Summary of Submissions:

The tables below summarise the comments received during the advertising period of the proposal, together with the Administration's response to each comment.

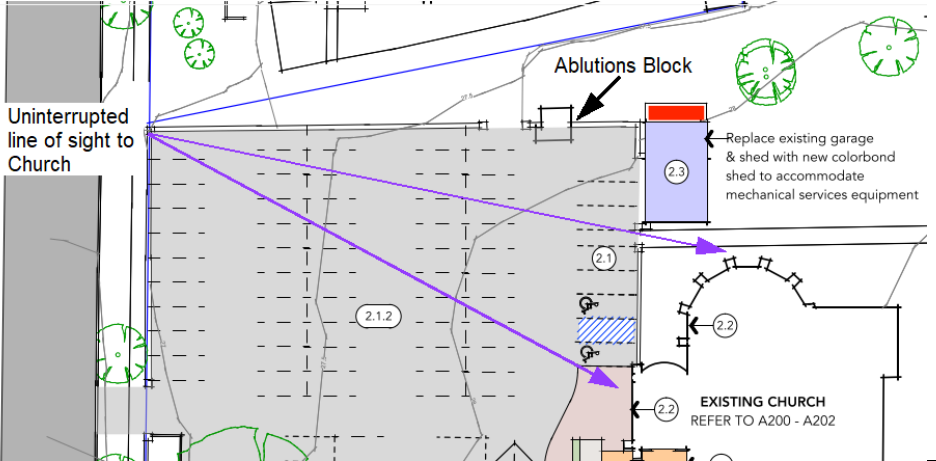
Comments Received In Objection:	Administration Comment
<ul style="list-style-type: none"> The proposed location obscures the surrounding viewing space of the church and historical gardens and view lines are negatively impacted. 	<ul style="list-style-type: none"> The Conservation Plan outlines that the significant vistas for the subject site are from Vincent Street. Due to its location behind the Church, the outbuilding would not impact significant vistas. <p>Existing views of the Church from Alfonso Street would be maintained. The car park to the west of the Church is bounded on the north and east by a limestone fence that is approximately 1.9 metre high and was constructed in 1956. A masonry and tile ablutions block is located approximately 39 metres from Alfonso Street and is integrated into the northern portion of the limestone wall. means that views of the Church from Alfonso Street are interrupted and would not be further impeded by the proposal. This is demonstrated in the figure below, which shows the line of sight from the northwest corner of the car park.</p>

Images Included with Submissions

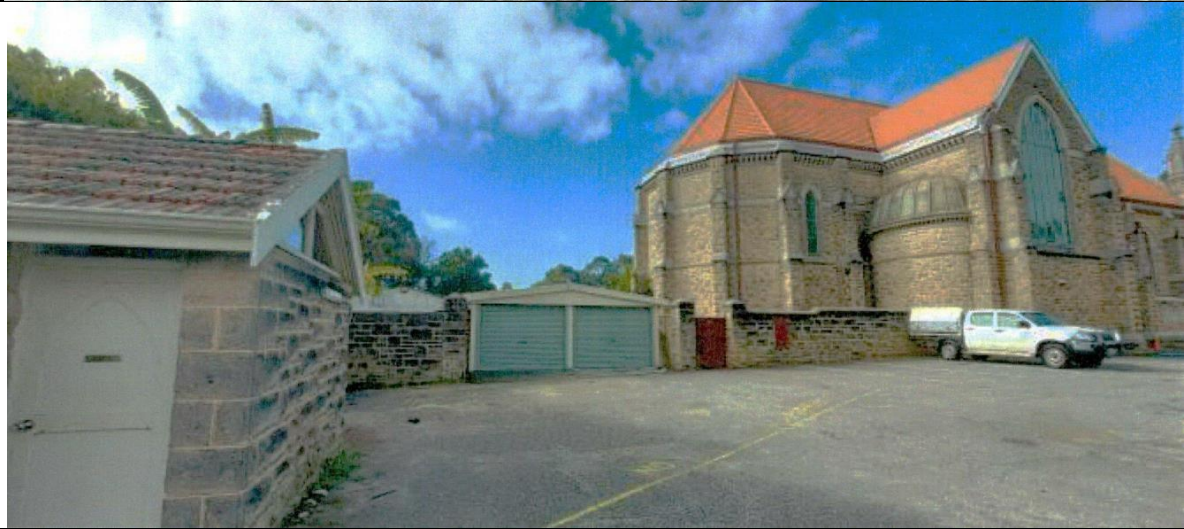
Enhance vista from Alfonso Street by removing the Colorbond gabled shed and exposed roller doors.

Relocating the plant room behind the existing garden wall will allow breathing space and appropriate distancing to the Church ambulatory.

Installing a wrought iron gate and fencing to match existing will allow grater connectivity to the existing garden.
